City of Portsmouth Planning Board

Property Address: 161 Deer Street

Application #: LU-22-173

RE: Request for Site Plan Approval at 161 Deer Street to be known as 70 Maplewood Avenue, Mixed Use Site Development

J:\JOBS\202005\2271\2022 Site Plan\Plans & Specs\Site\2271.04 TURNING TEMPLATE 2022.dwg, Tue Nov 8 08:22:37 2022, SHARP MX-3071 (0300380X00)

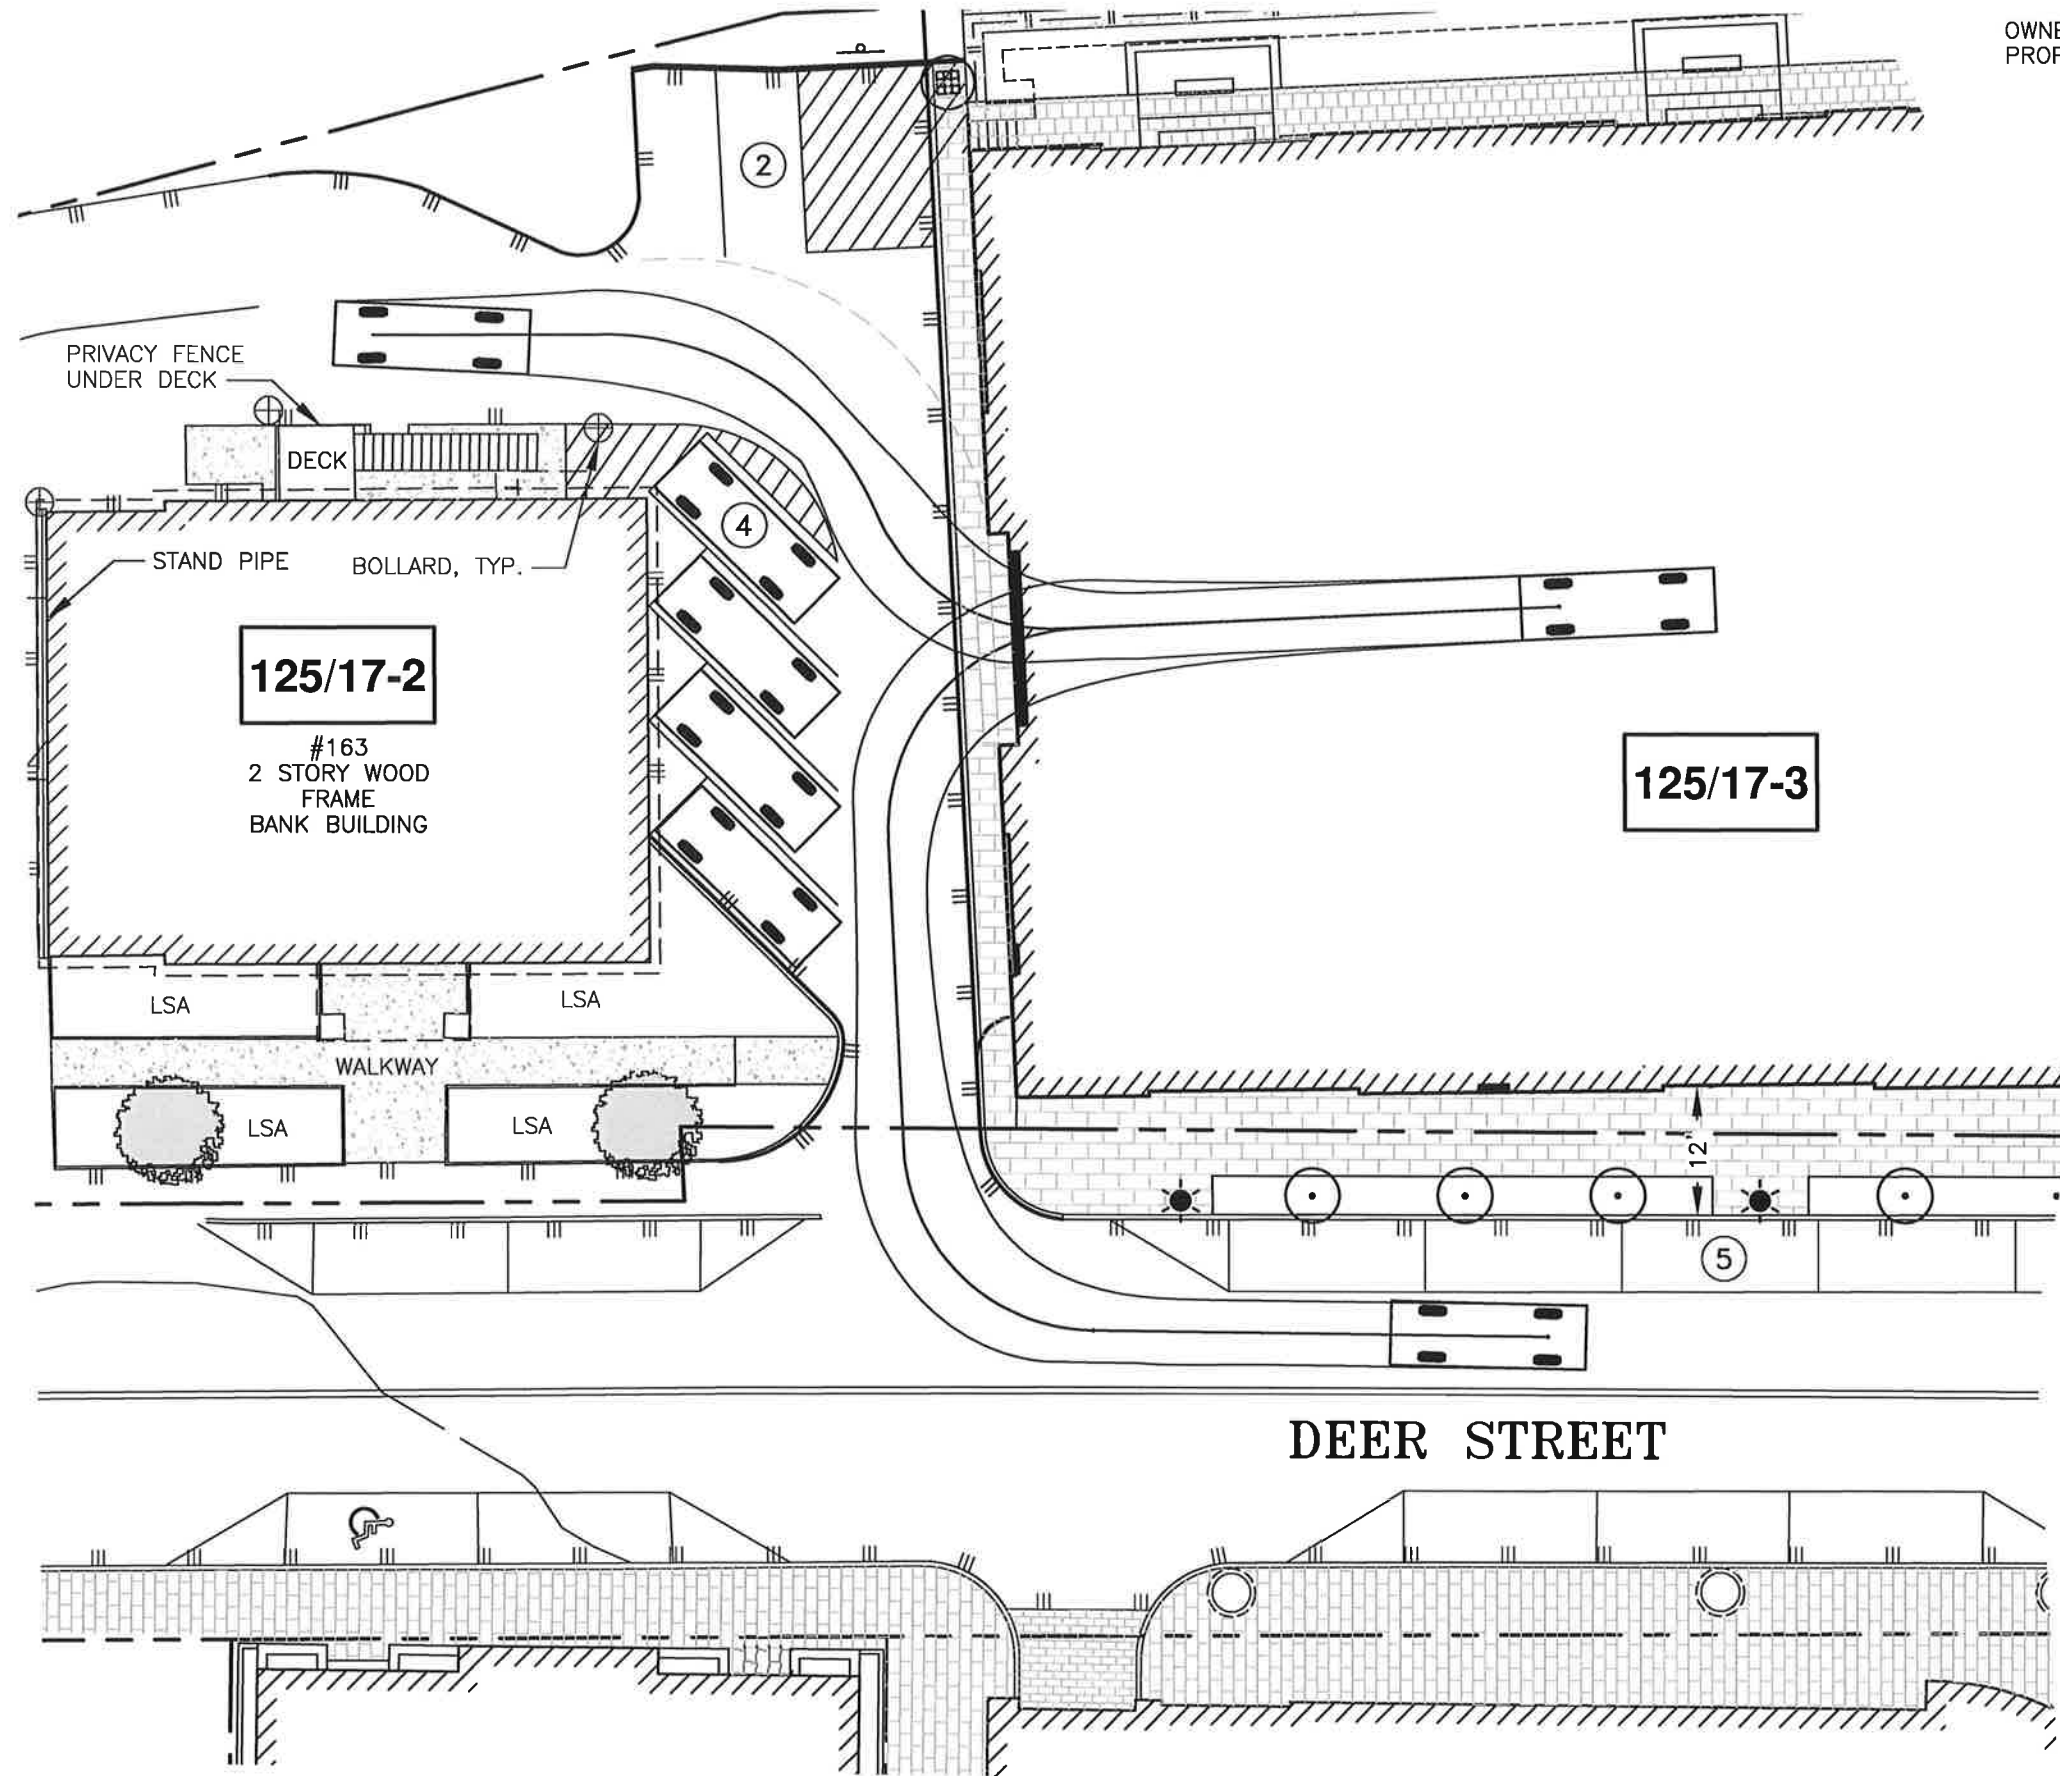
9. Applicant will work with Eric Eby to determine proper width of parking level entrance. **The building entrance has been set back 2 feet +/- to accommodate a larger specified vehicle, the door expanded, and the vehicle turning plan has been updated.**

PARKING LEVEL PLAN **C4**

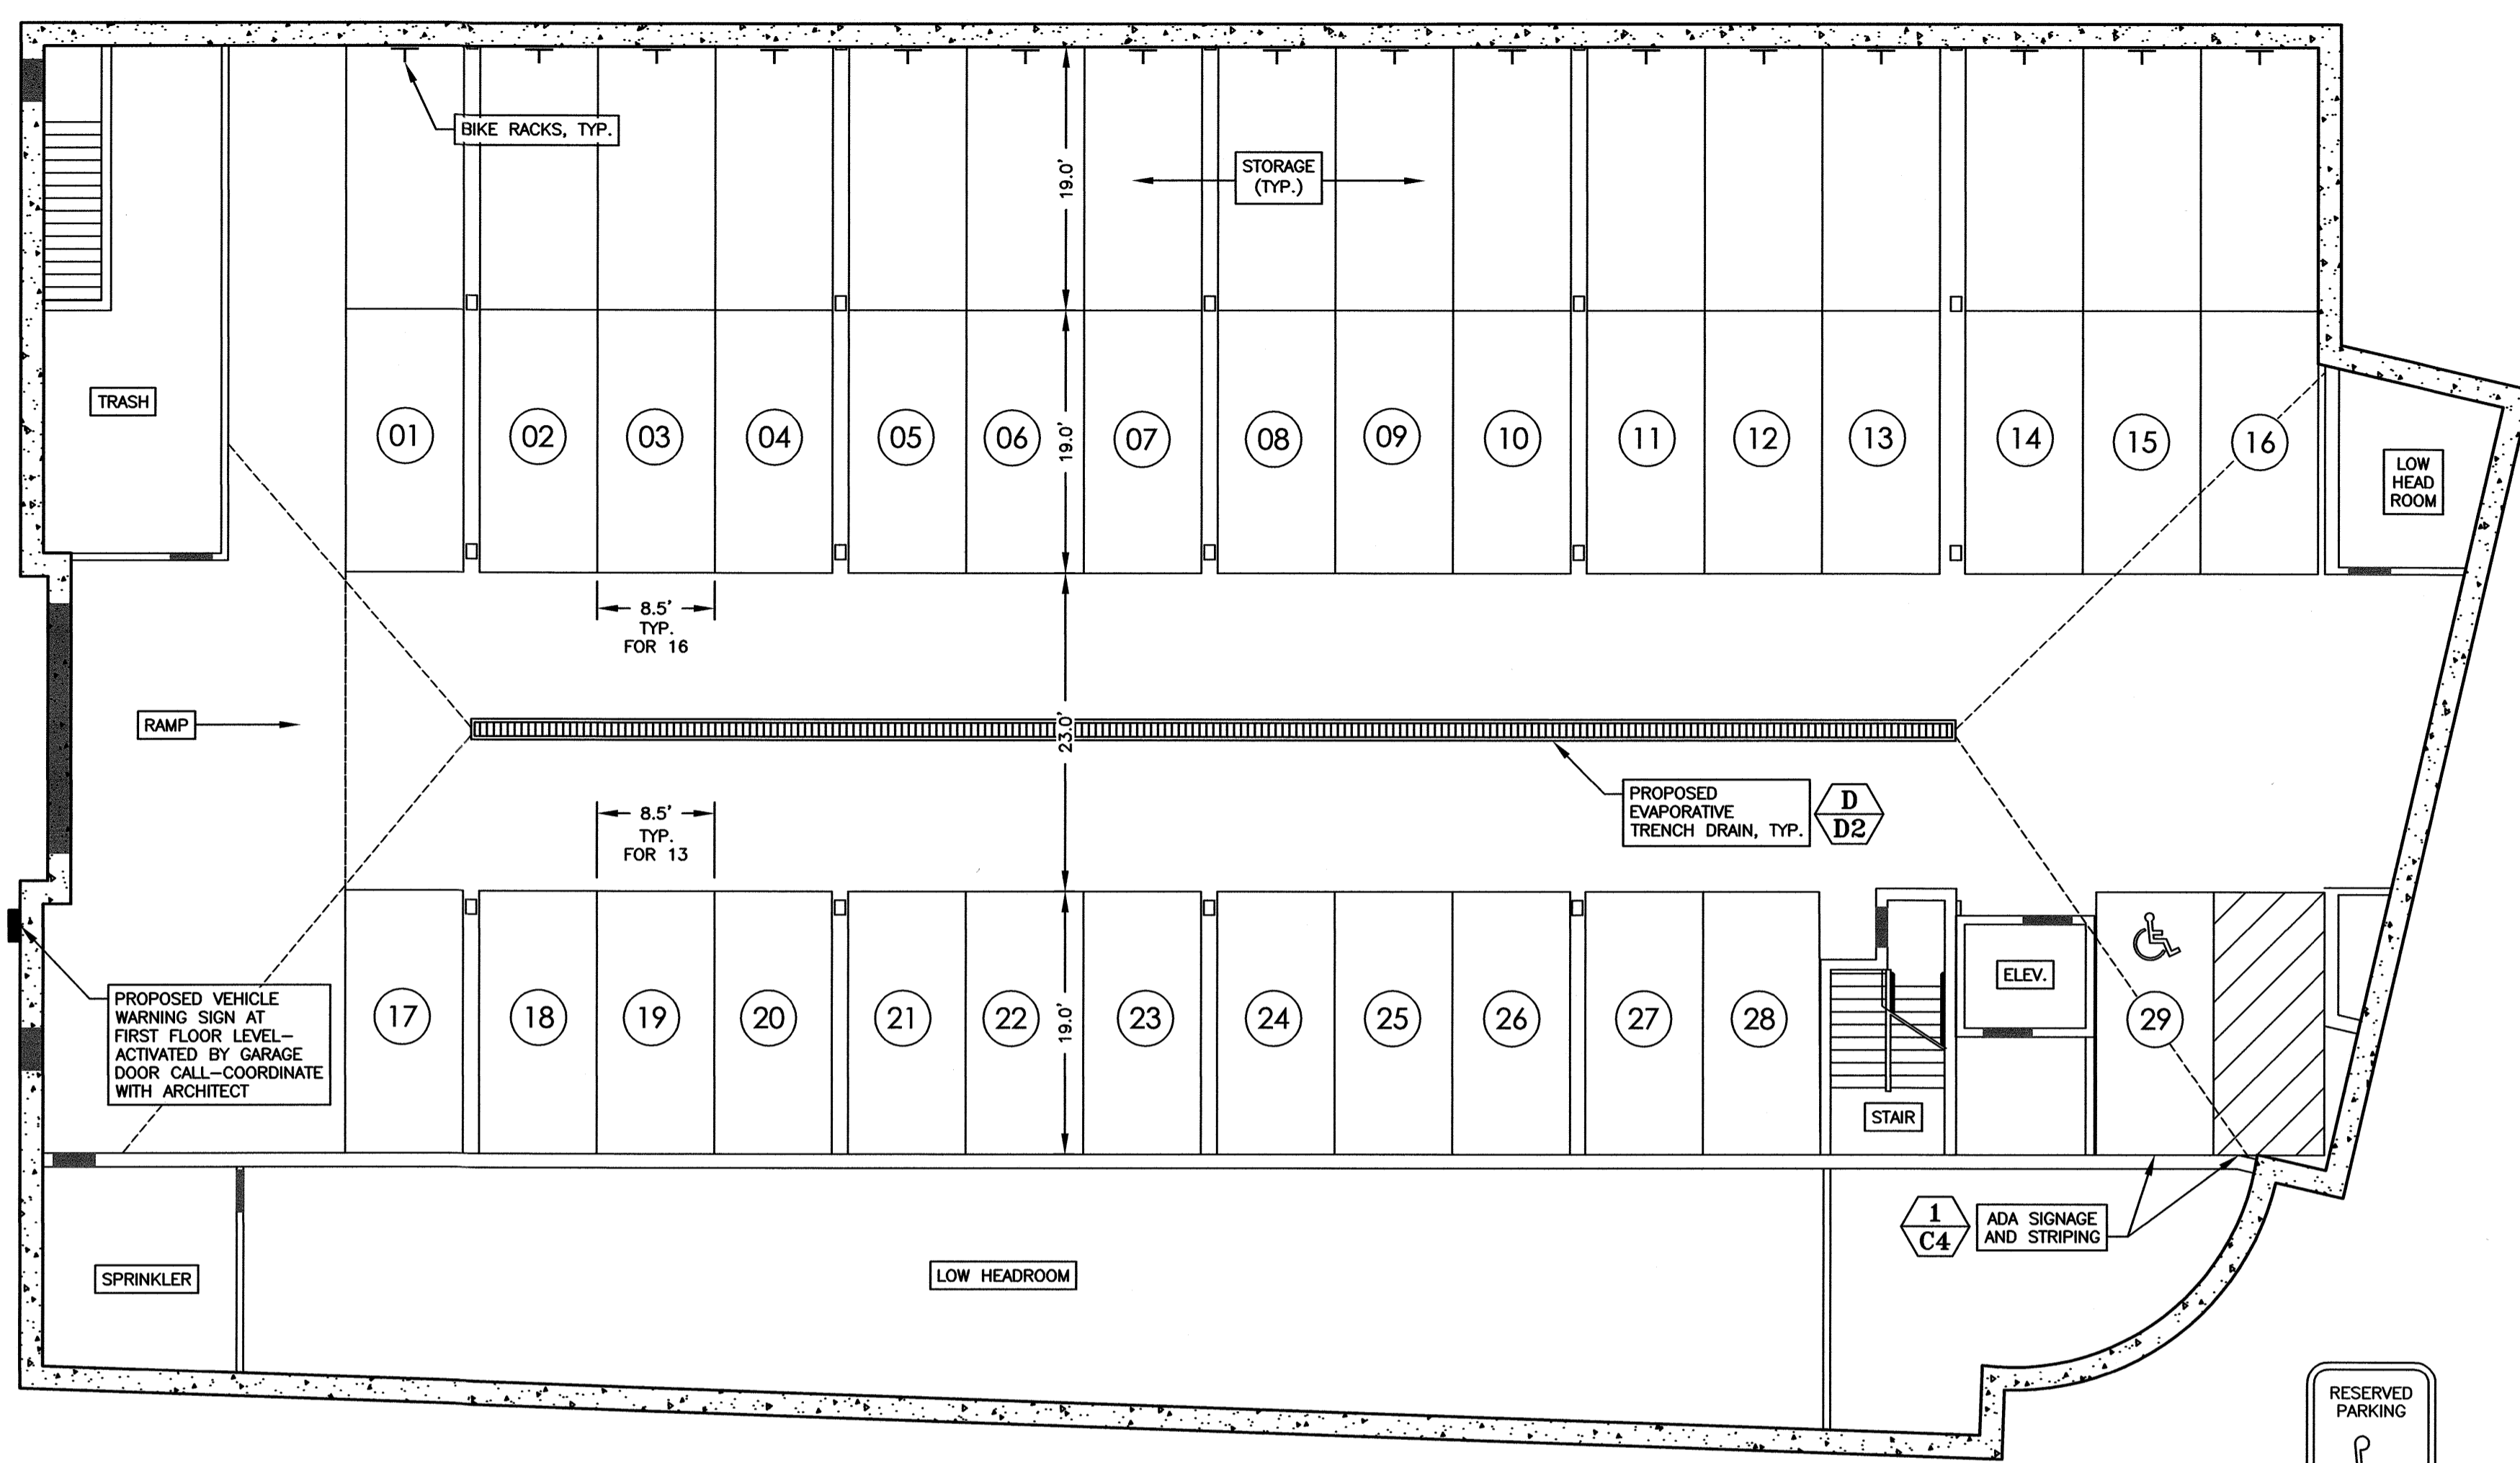
5. New layout of the sprinkler room will be reviewed and approved by Department of Public Works. **The Sprinkler Room has been updated on Sheet C4. The entrance will be in an area of low clearance with a 90-degree bend to get to the full height room.**

UTILITY PLAN **C5**

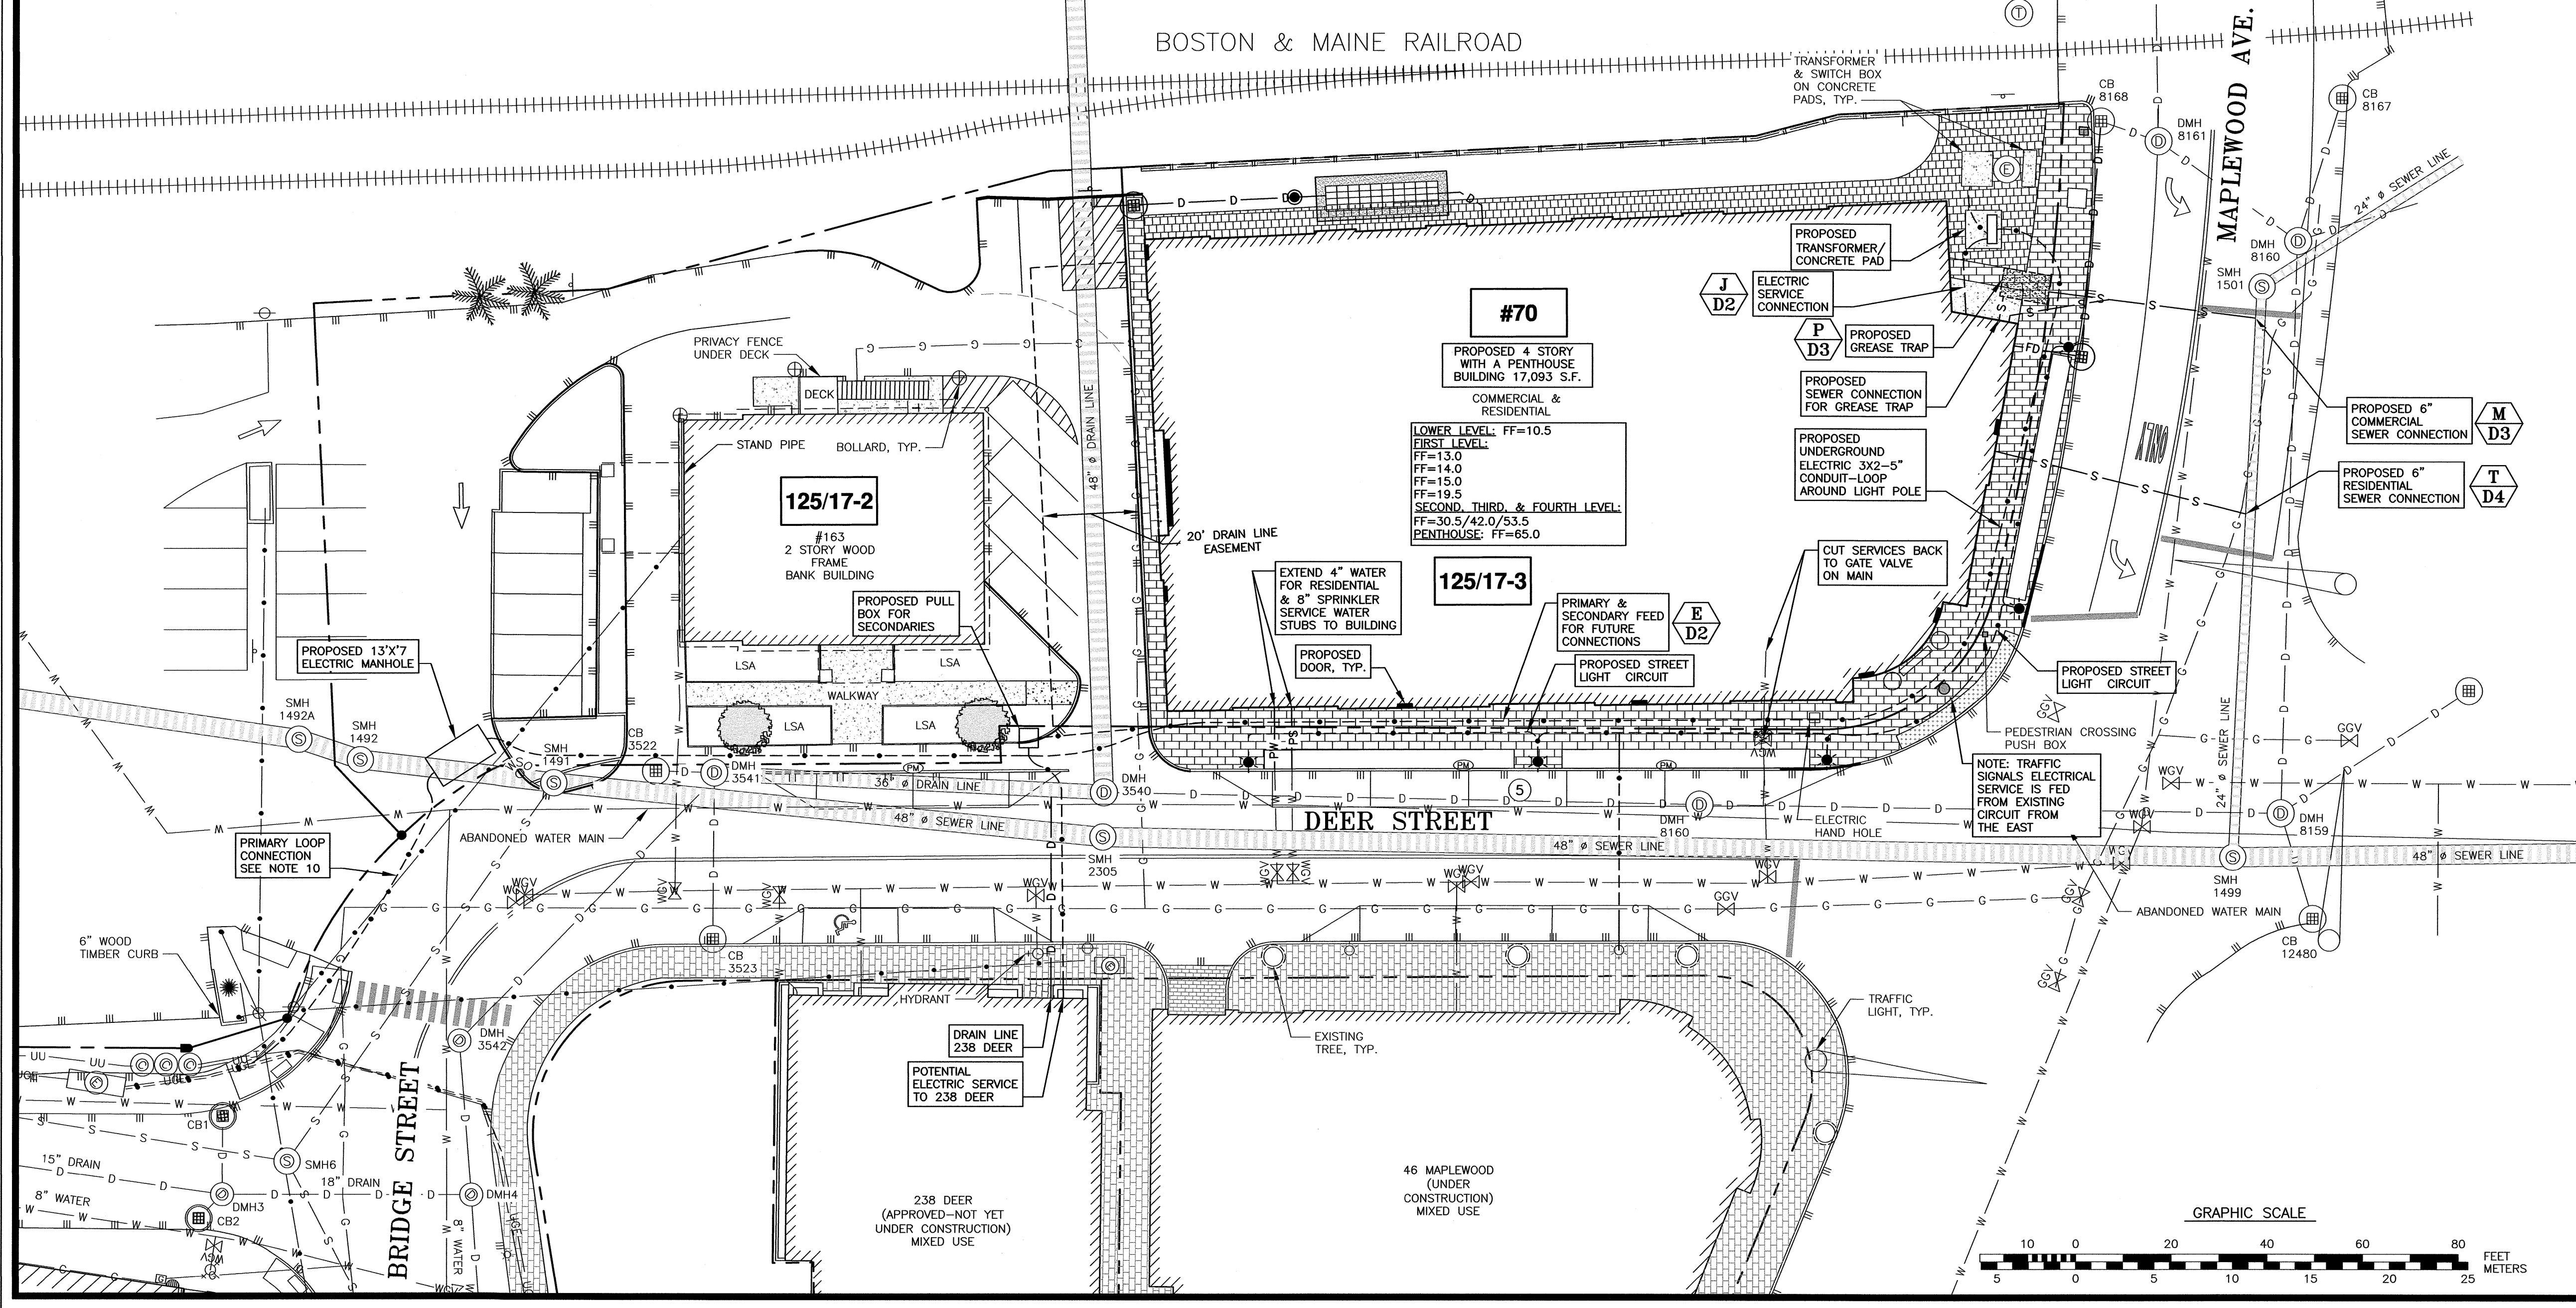
6. Applicant will update street lighting circuit to originate from a streetlight or streetlight pull box for Department of Public Works review and approval. **The Sheet C5 plan has been updated.**

7. Updated language pertaining to extending existing water stubs to building (call out box in southern corner of proposed building, sheet C-5) will be reviewed and approved by DPW. **The note was revised on the plans for final review.**
